**Aircraft hazard assessment of the proposed
Silverton Wind Farm**

April 2008

1.1.1 Aircraft hazard impacts

Location of airstrips in relation to the proposal

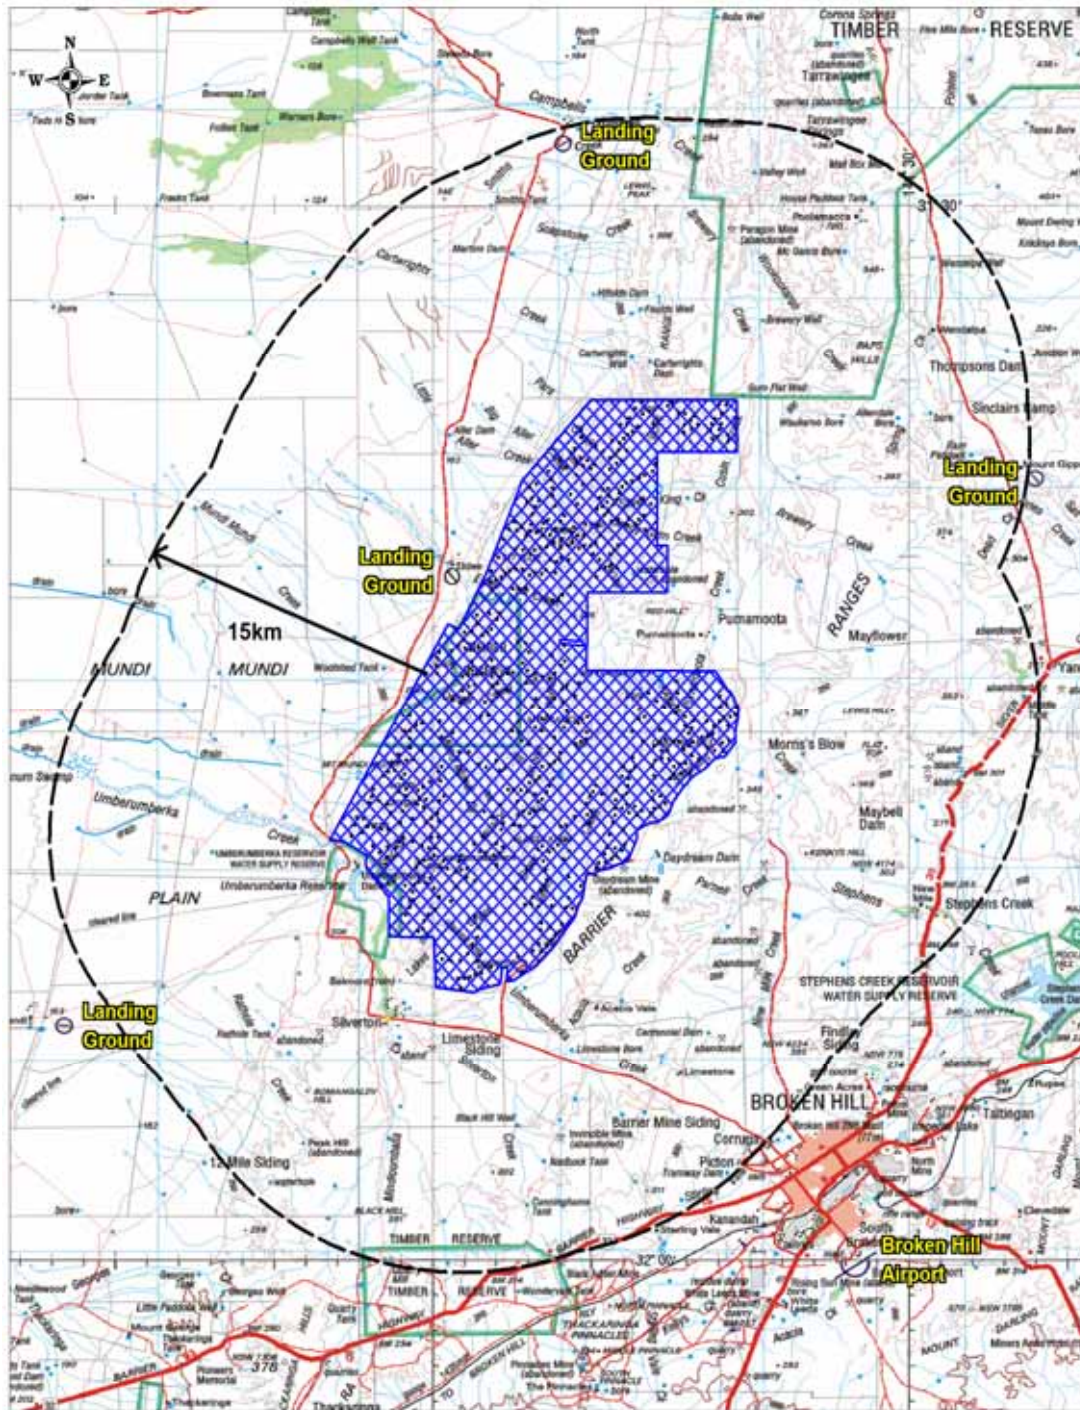
The minor, private airstrips in the local area rely on visual rather than instrument based landings and as the turbines are clearly visible structures it is unlikely that the development would pose any additional hazard to the users of these airstrips.

- EPURON will provide the “as constructed” location and height of each tower to the Australian Aerial Agriculture Association.
